CUP16-00098 & CVA16-00074 – Hatch Design Architecture

Planning Division Staff Report

File Number	CUP16-00098 & CVA16-00074
Applicant	Hatch Design Architecture
Property Address	12067 W. Ustick Road
Public Hearing Date	January 9, 2017
Heard by	Planning and Zoning Commission
Analyst	Leon Letson
Checked By	Cody Riddle

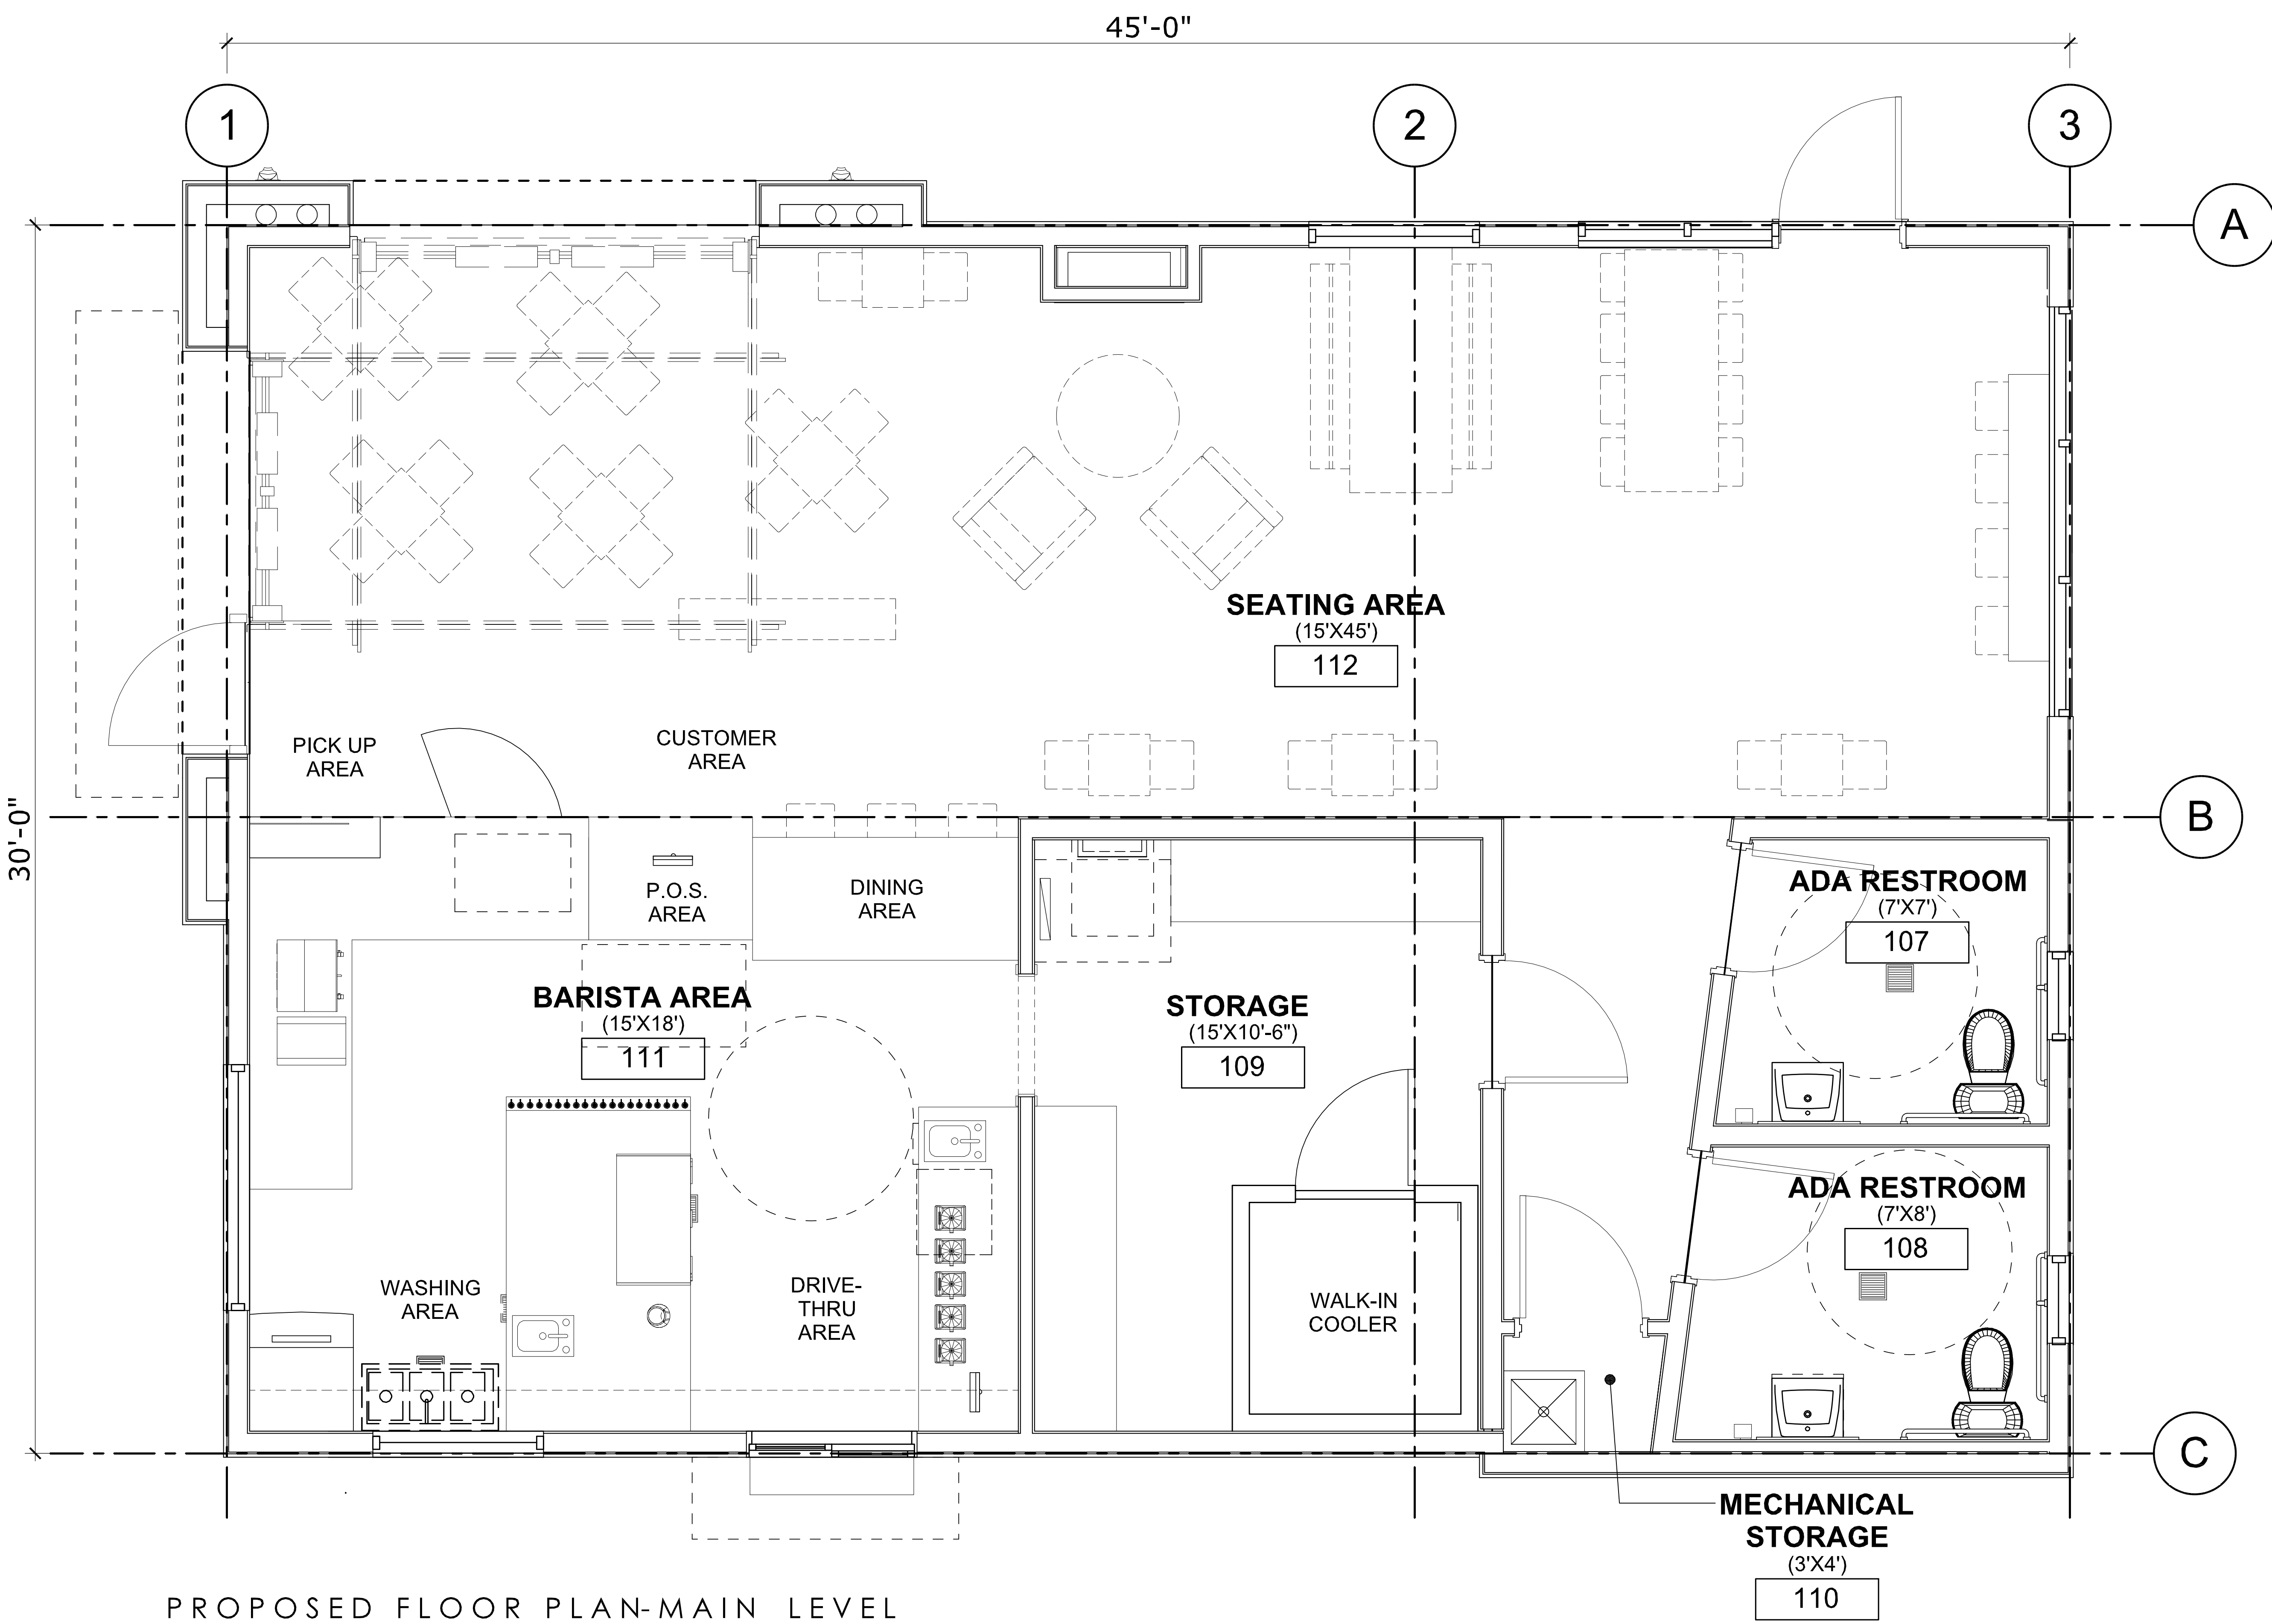
1. Remove the landscape buffer between the most southern drive-thru lane and the one-way exit lane; shift the one-way exit lane to the north to increase the landscape buffer along the southern portion of the site. **We prefer the current plan as discussed with Jeff at our face-to-face meeting. We believe the architect has planned for sufficient buffer space.**

2. Install a mix of Class II coniferous and deciduous trees in the landscape buffer along the southern portion of the site that will provide a minimum 60% screen at maturity. **Agree (see item 4 below).**

3. Provide a 5' sidewalk along the western side of the drive aisle shared with the housing development to the south, from the north side of the proposed crosswalk to Ustick Road. This will allow you to maintain a 4' landscape buffer between this sidewalk and the drive-thru lane. **We do not agree with this plan change. We believe we need the 8' buffer to facilitate the installation of an adequate hedge row to screen this area from the dentist office. We want to keep the current design plan.**

Figure 1

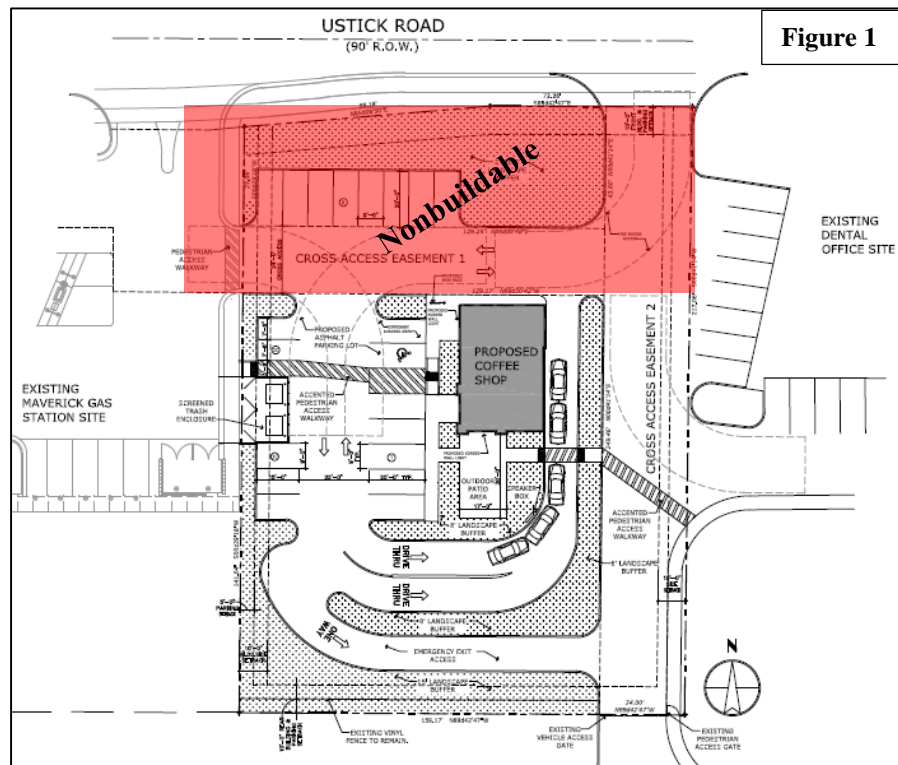
The applicant requests approval of a conditional use permit for an approximately 1,300 square foot coffee shop with drive-up window located on a 0.81-acre parcel located at 12067 W. Ustick Road in a C-1D (Neighborhood Commercial with Design Review) zone (**Figure 1**). A variance to locate the drive-up window and lane within 200’ of residential property is also included. The subject property is encumbered by a City of Boise sewer line easement that runs parallel with Ustick Road. This easement and

the required setbacks of the C-1D zone severely restrict the development potential of the front 60' of the property. The area associated with the sewer easement is also utilized to provide cross-access to a retail store with gasoline service to the west, a dental office to the east, and a multi-family residential development to the south. Located within a mixed use corridor along Ustick Road, other adjacent uses include a multi-family residential development to the north (Figure 2).
